Residential Development @
VICTORIA PARADE, MANLY, NSW

SITE GROUND PLAN

SOUTH ELEVATION

EXTERIOR MATERIALS – Addendum 1 - Non Trafficable Roof Terrace

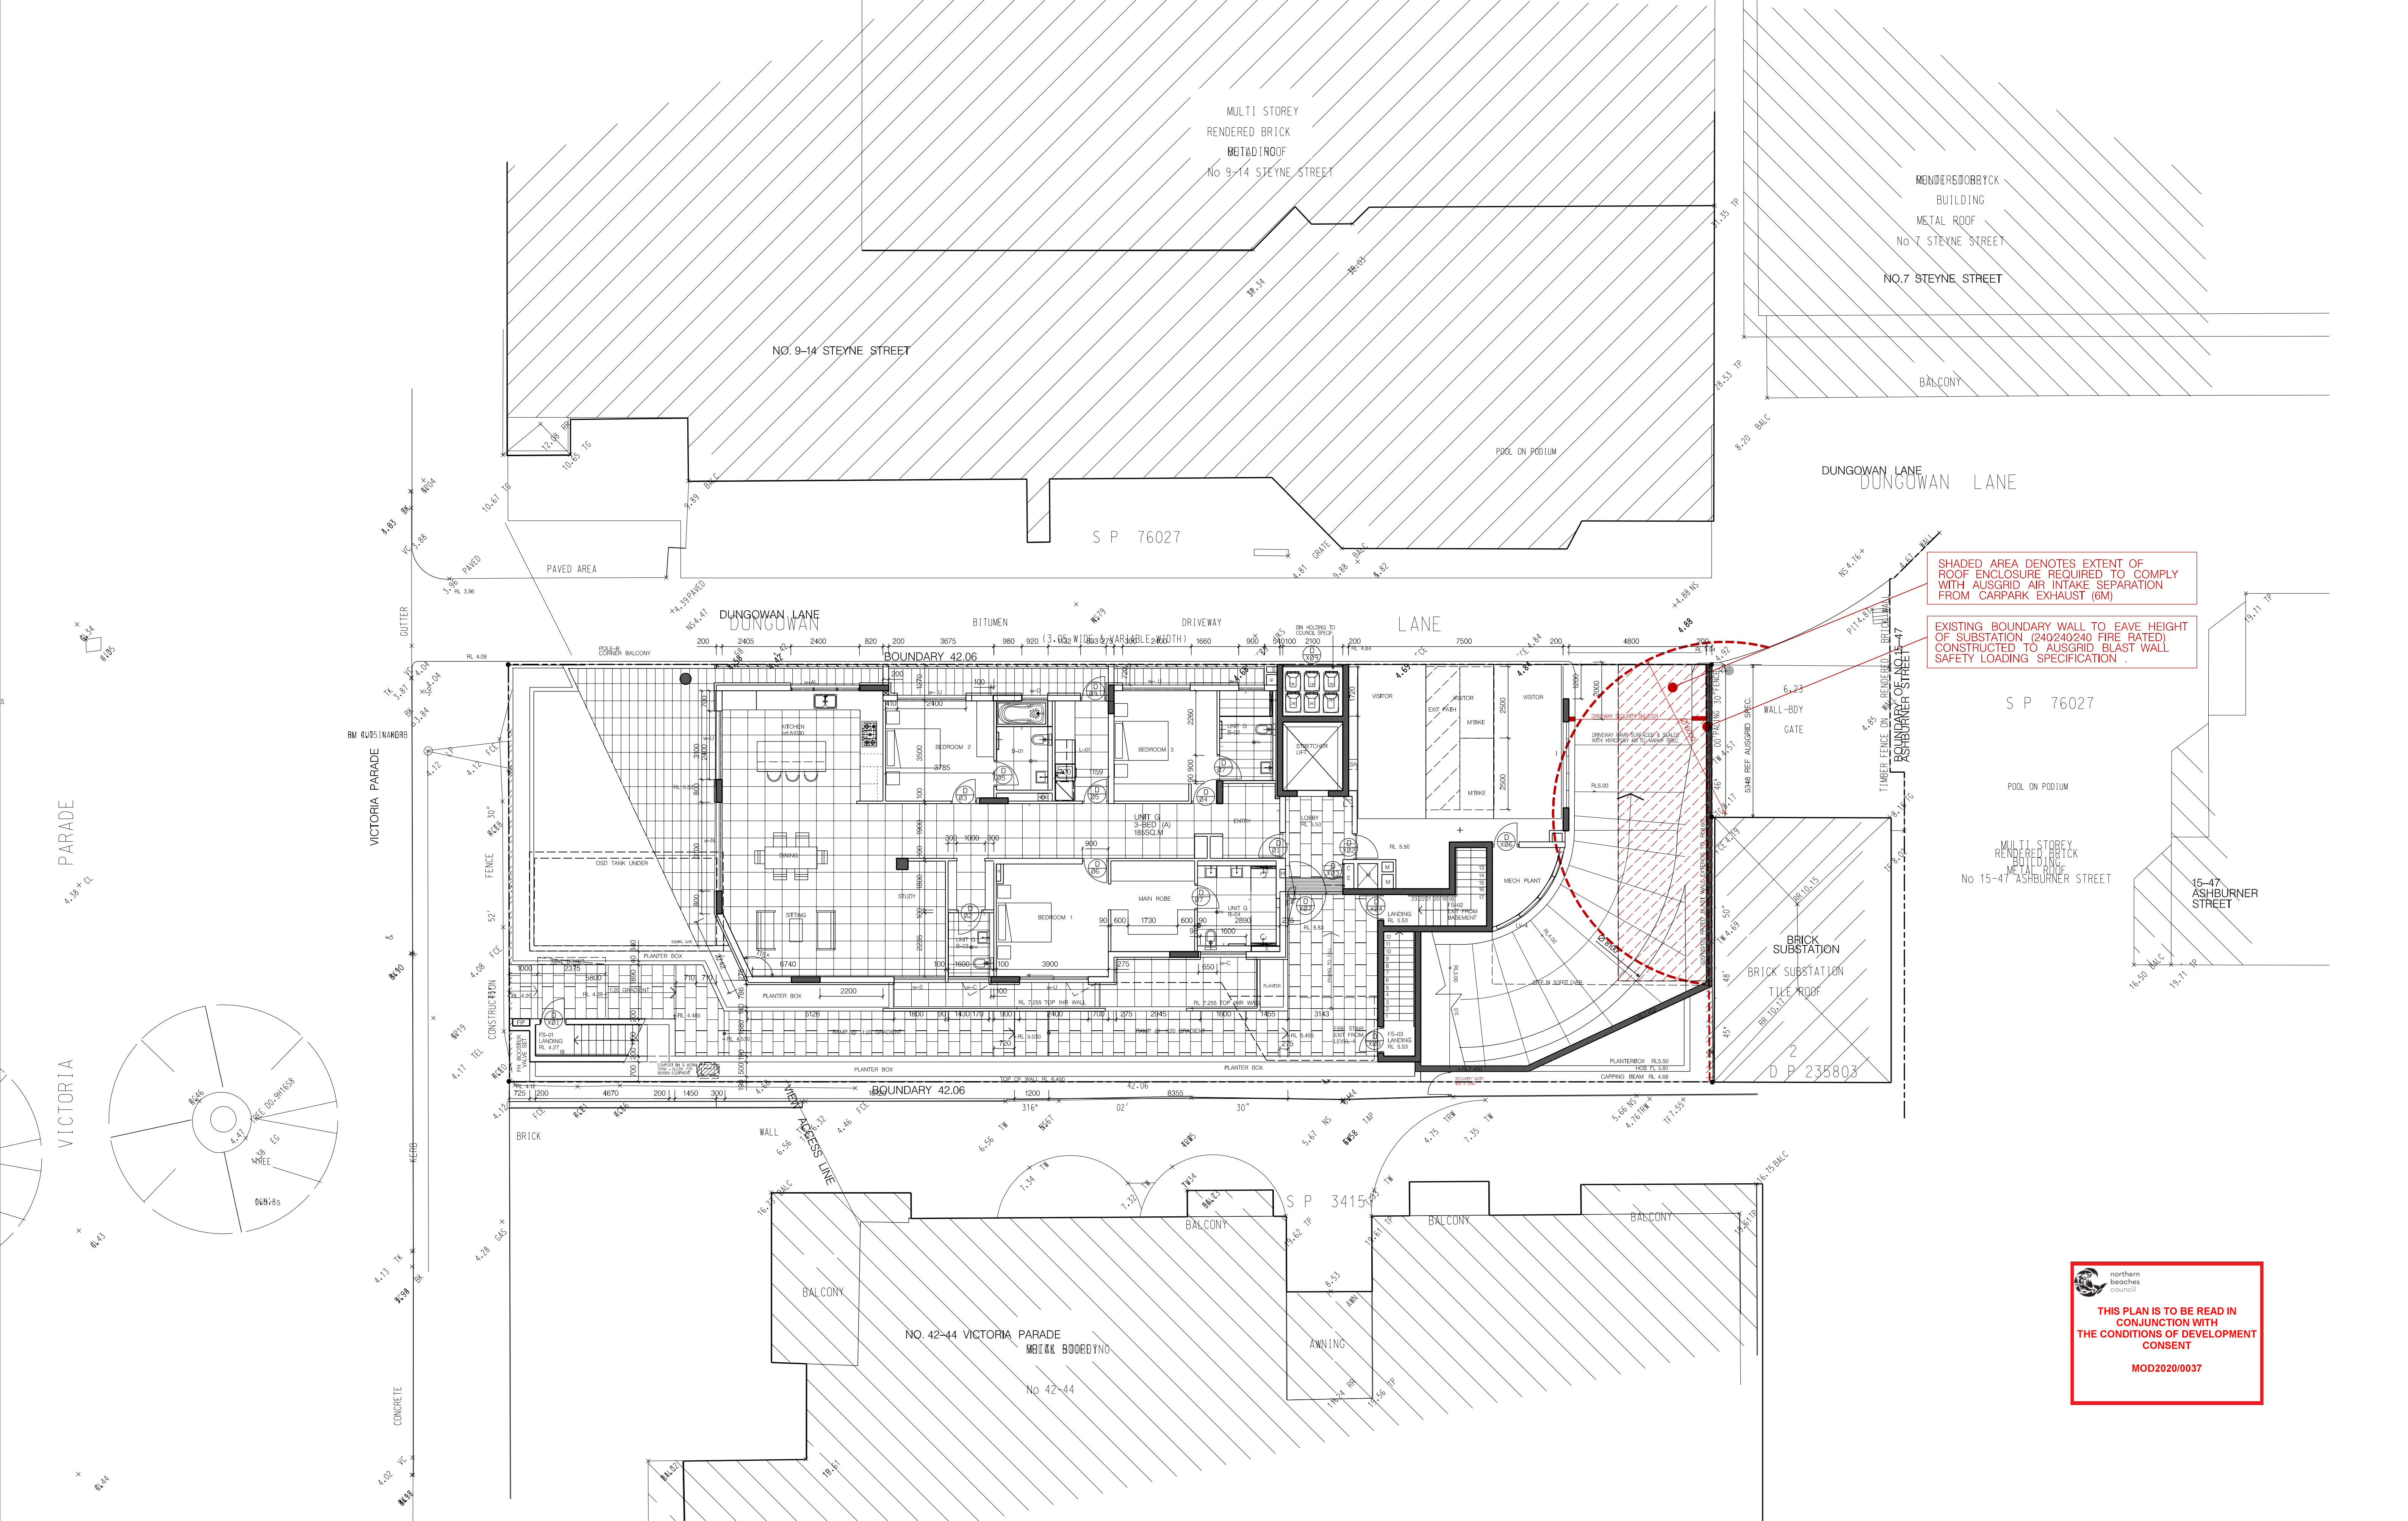
SHADED AREA DENOTES EXTENT OF ROOF ENCLOSURE REQUIRED TO COMPLY WITH AUSGRID AIR INTAKE SEPARATION FROM CARPARK EXHAUST (6M)

EXISTING BOUNDARY WALL TO EAVE HEIGHT OF SUBSTATION (240x240x240 FIRE RATED) CONSTRUCTED TO AUSGRID BLAST WALL SAFETY LOADING SPECIFICATION

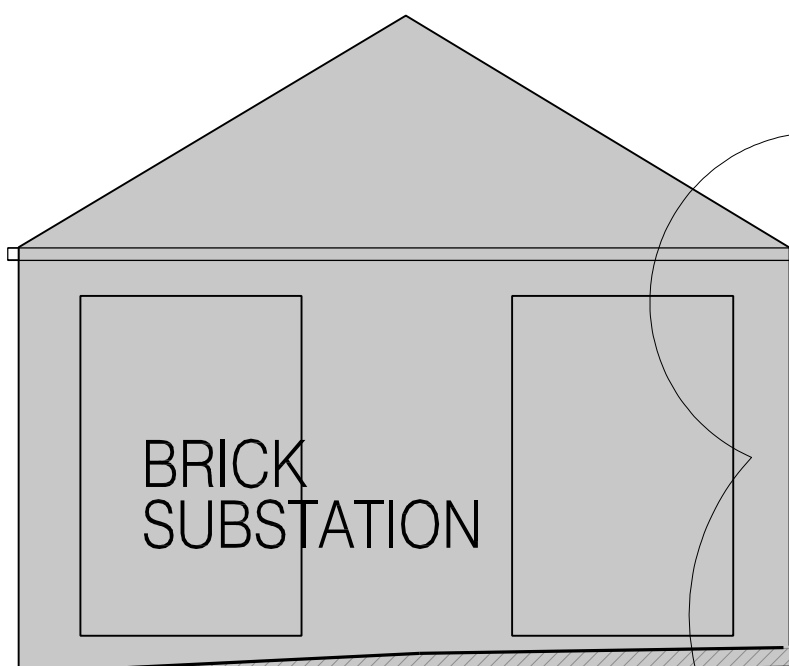
DRIVEWAY ROOF ENCLOSURE SPANNING TO EXISTING BOUNDARY BLAST WALL

REQUIRED DRIVEWAY ROOF SLAB
& PLANTERBOX 1800x1800 WITH
TGLASS BALUSTRADE (SHADED)
TO AUSGRID SPECIFICATION
CARPARK DRIVEWAY 2400x2400 BOUNDARY BLAST WALL

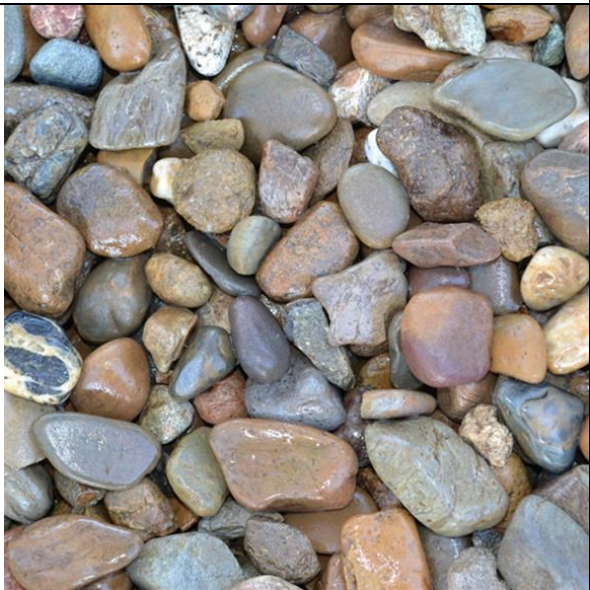
CONCRETE ROOF					
Code	Image	Location	Description	Specification	R
CR1		Level 1 – South Concrete Roof over driveway entry ramp	200mm RC suspended slab 180/180/180 with seamless Waterproof membrane covered with impact board for 60mm deep pebble ballast evenly spread. Ref drawing A002 for extent	Sandy/Brown washed river gravel. Ensure gravel size is adequate to prevent removal by birds. (30mm-40mm diameter) Australian Native Landscapes (\$106/tonne)  THIS PLAN IS TO BE READ IN CONJUNCTION WITH THE CONDITIONS OF DEVELOPMENT CONSENT MOD2020/0037	A
